Draft amendment to ECE/TRANS/WP.29/GRSP/2010/26

The text reproduced below was prepared by the expert from France as a result of the last meeting of the informal group on child restraints systems (CRS) regarding a proposal for a new Regulation on CRS.

Draft new Regulation on uniform provisions concerning the approval of enhanced child restraint systems used onboard of motor vehicles

6.3.4.1. ~~Support leg contact volume requirements~~

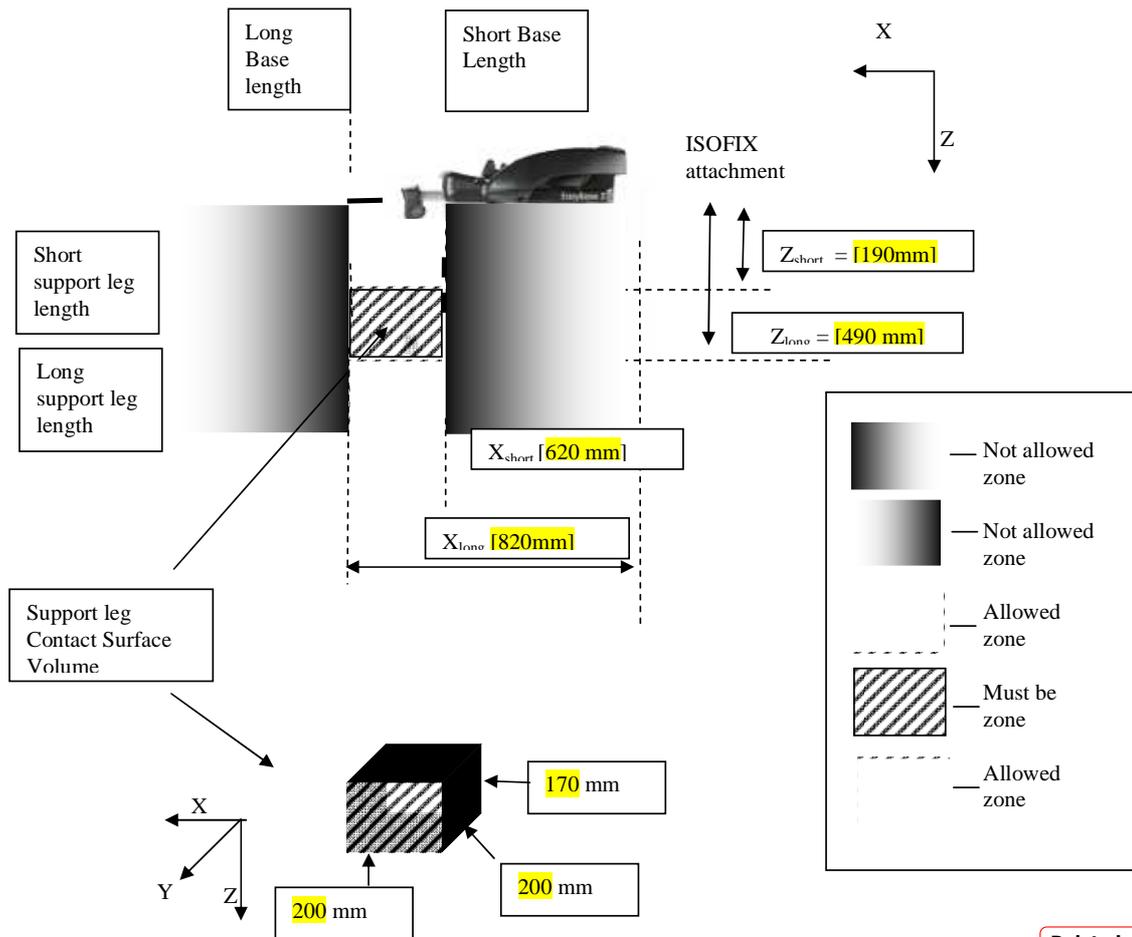
- X X_{short} must be [620] mm or larger, from the ISOFIX anchor, measured in X direction.
- X X_{long} must be [820] mm or shorter, from the ISOFIX anchor, measured in X direction. Comment: could 820 mm be reduced to reduce vehicle contact volume? (probable interference with front seats)
